Product Change Notification

Product Group: **Aluminum Capacitors**/September 22th, 2015/**PCN-AC-505-2015** Rev 0/ page 1 of 3

Colour Change of Insulation Sleeve, Radial Products

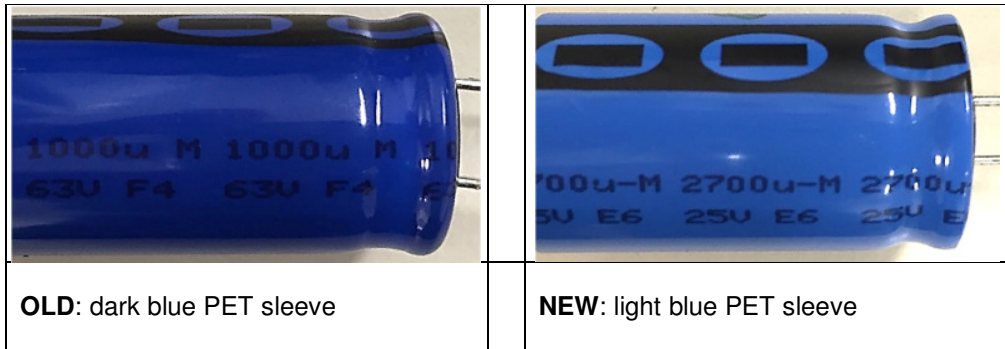
DESCRIPTION OF CHANGE: Insulation colour change of Radial Aluminum Capacitors. Change from dark blue coloured PET sleeve to light blue coloured PET sleeve at case sizes between 10x12mm and 18x40 mm.

REASON FOR CHANGE: Better visibility and standardization reasons. Change was already done for axial products.

EXPECTED INFLUENCE ON QUALITY/RELIABILITY/PERFORMANCE: There will be no negative effect on the quality, reliability and/or performance. Dark and light blue PET material are completely identical, excepted amount of blue colour pigments.
